RESUBMIT Yes Rejected
BY M. J. Chenette DATE 05/22/2014

SHOP DRAWING REVIEW

ITEM #: 900.640 SOLD TO: F.R. LAFAYETTE (PO#28720) SHEET 1 OF 2

APPROVED BY: **SPECIAL PROVISION BRIDGE RAIL, GALV. HDSB/FM/ST**
BRATTLEBORO BRO 1442 (35) TH 12, CLASS III (LOCAL ROAD), BRIDGE NO. 7
TOWN OF BRATTLEBORO, COUNTY OF WINDHAM, VERMONT

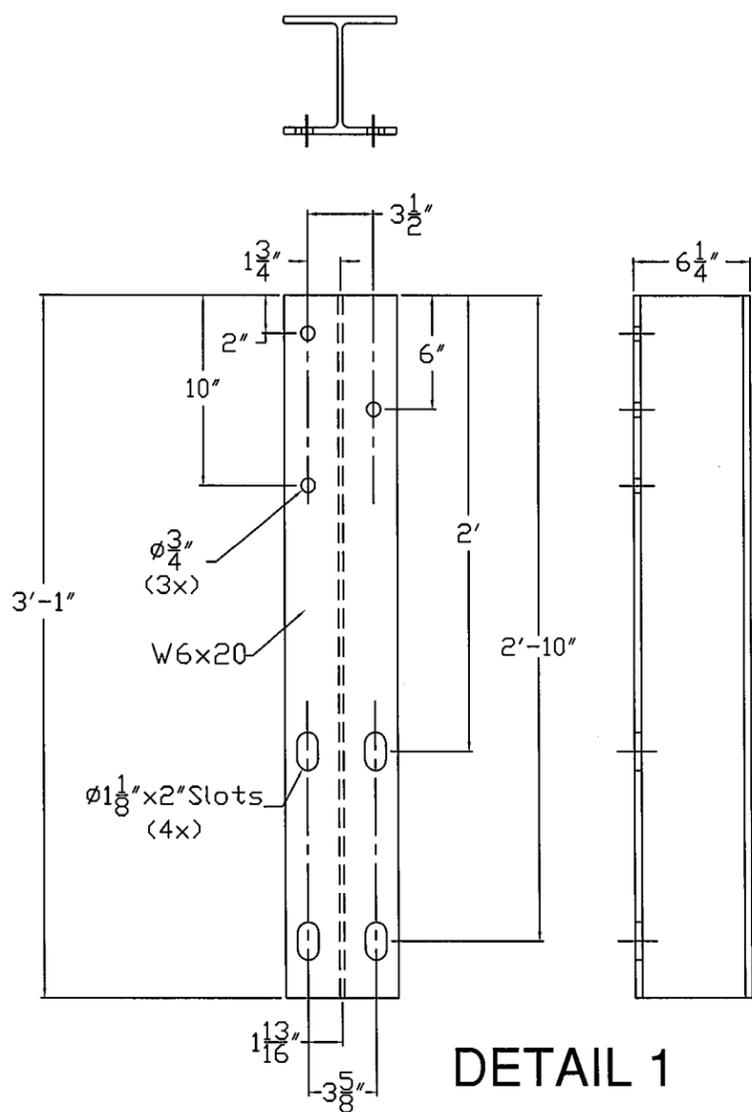
Show end of bridge/Wingwall and label max/min dimension

Include welding details

add units, "950 FT"

DETAIL 9

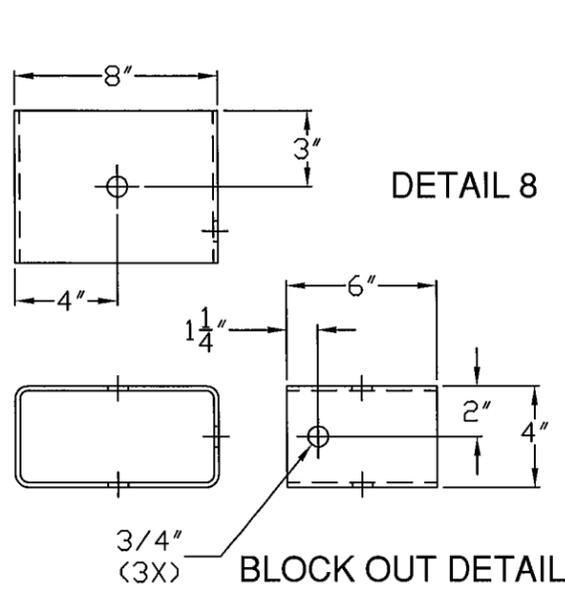
These callouts are confusing. Are they referring to details? Include all details (typ)

Last Post/Rail Detail

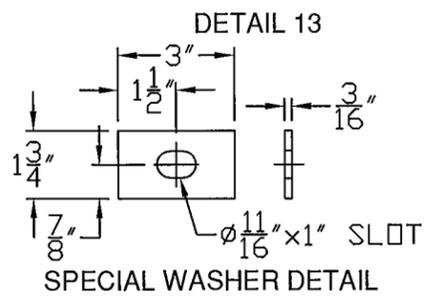
Please show a section through the rail and show how it is connected to the post.
